CONDITIONS OF APPROVAL:

Engineering - Final Plat Checklist

13. C. Final Plat

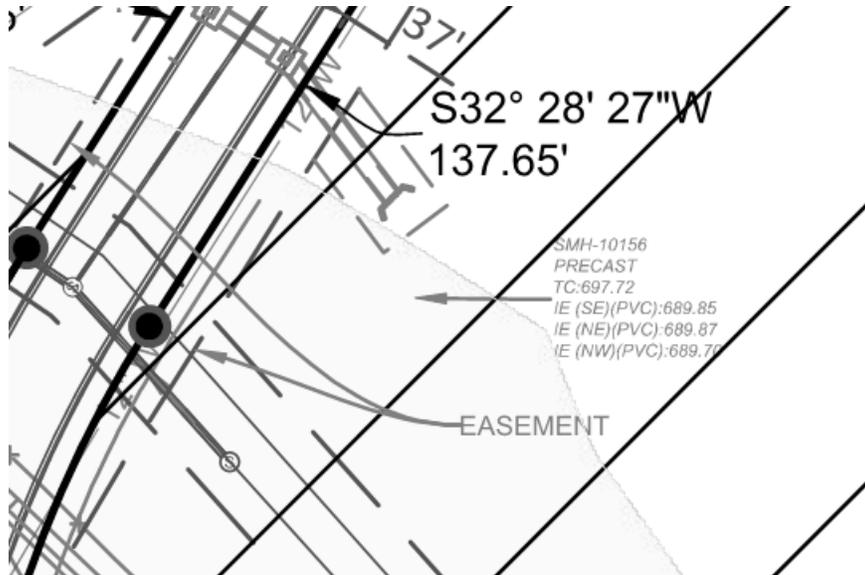
lance.fittro@franklintn.gov The previous comment, "Applicant to show and label the top of bank lines, and show, label, and dimension stream and wetland buffers. Reference approved COF Site Plan 6143 Reams Fleming Infrastructure Improvements where applicable." does not appear to have been completely addressed.

The centerline of Five Mile Creek is clearly shown and labeled (thank you), but what appears to be top-of-bank of the creek is not labeled, what appears to be the outline of a wetland or its buffer is not labeled, and there do not appear to be any stream buffers for Five Mile Creek shown or labeled. Applicant shall show and label all of the features requested on the plat.

24. Legibility

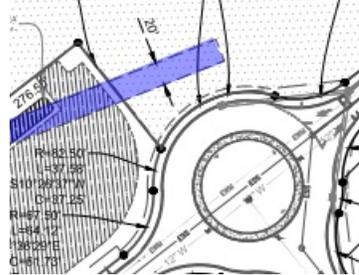
Applicant to shift text out of hatched regions for legibility. One example of many is shown below.

26. Easement

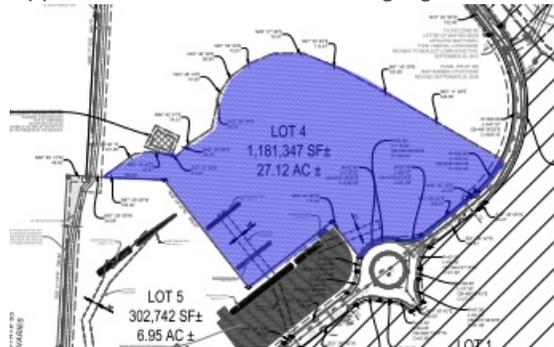
Applicant to label the easement highlighted below.
